REVISED NORTH ELEVATION

REVISED EAST ELEVATION

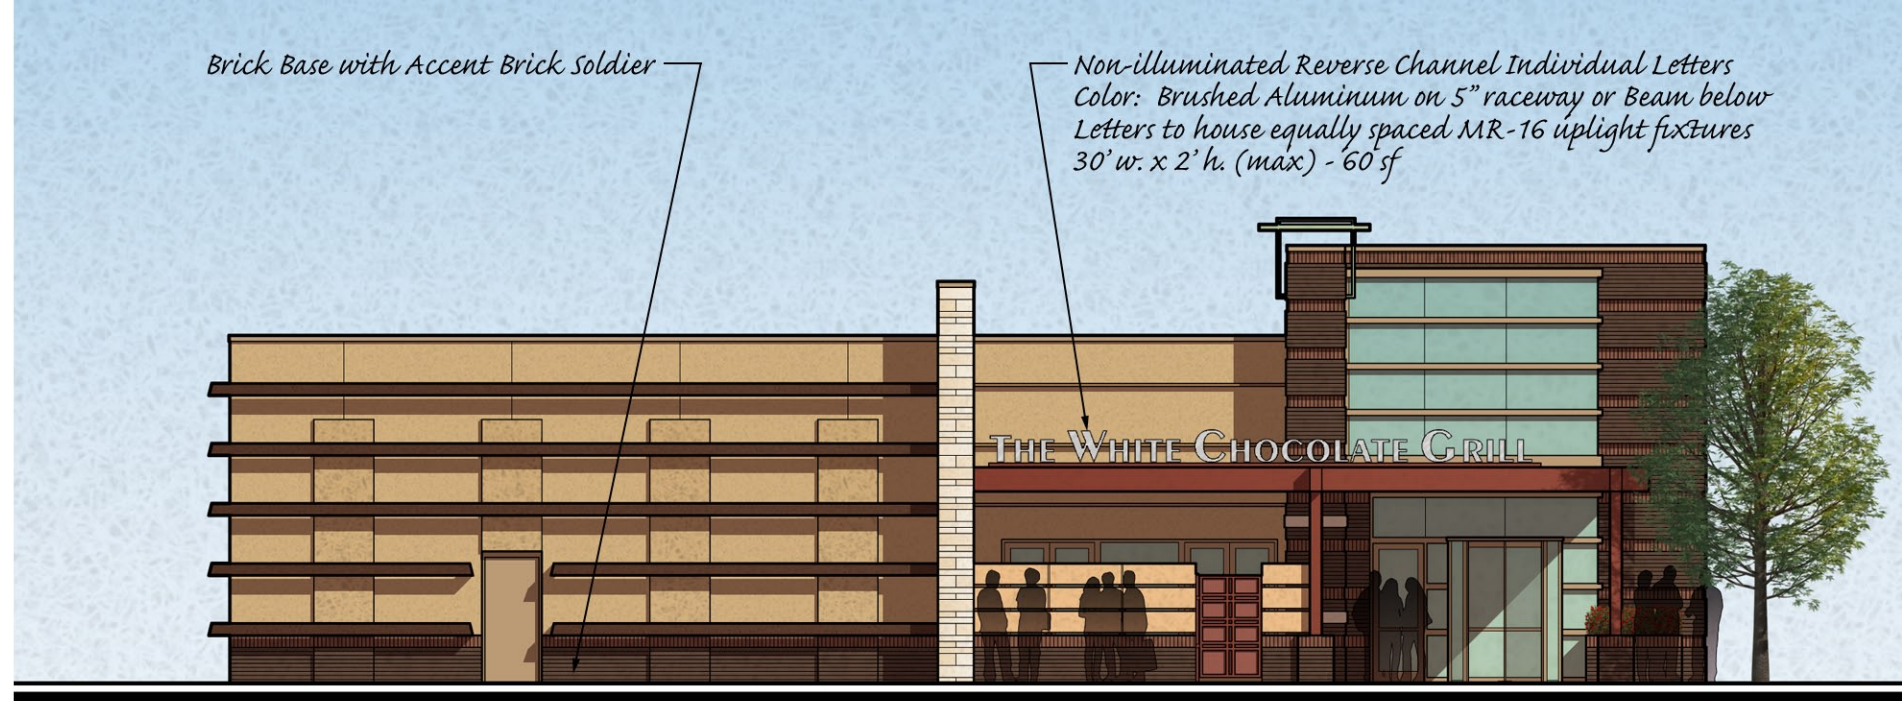
*Non-illuminated Reverse Channel Individual Letters
Color: Brushed Aluminum on 5" raceway or Beam below
Letters to house equally spaced MR-16 uplight fixtures
30' w. x 2' h. (max) - 60 sf*

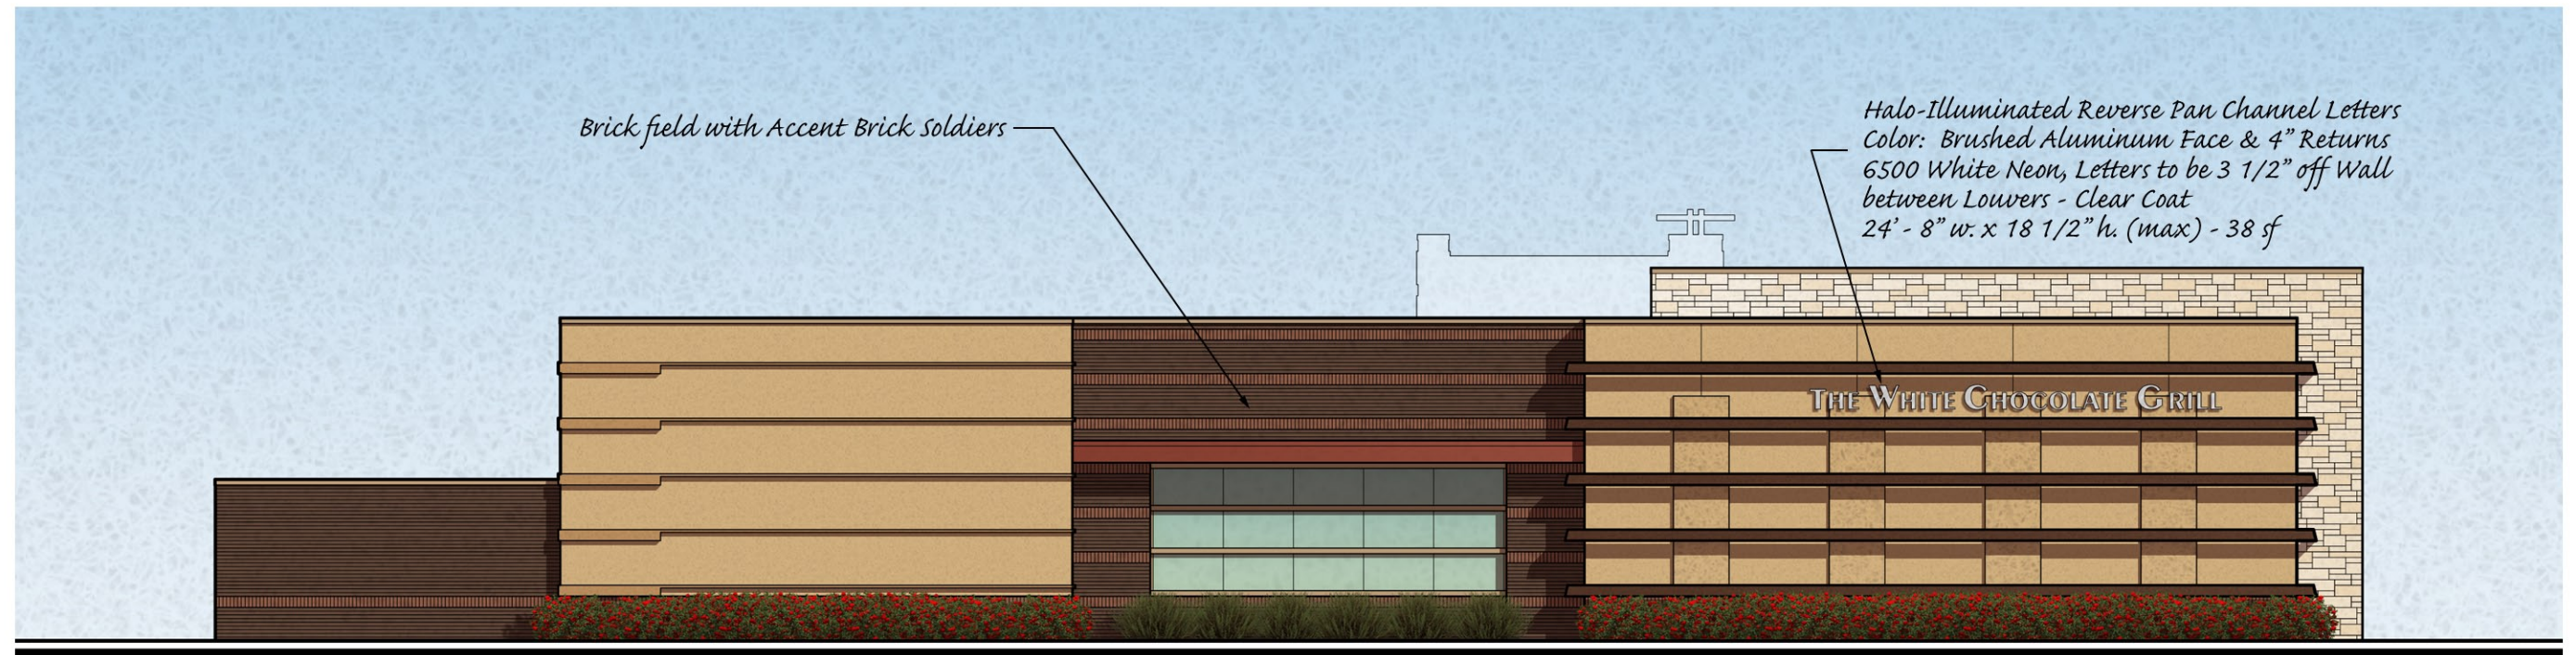
*Halo-Illuminated Reverse Pan Channel Letters
Color: Brushed Aluminum Face & 4" Returns
6500 White Neon, Letters to be 3 1/2" off Wall
between Louvers - Clear Coat
24' - 8" w. x 18 1/2" h. (max) - 38 sf*

Lowered Wall - Uplighted (Typ.)
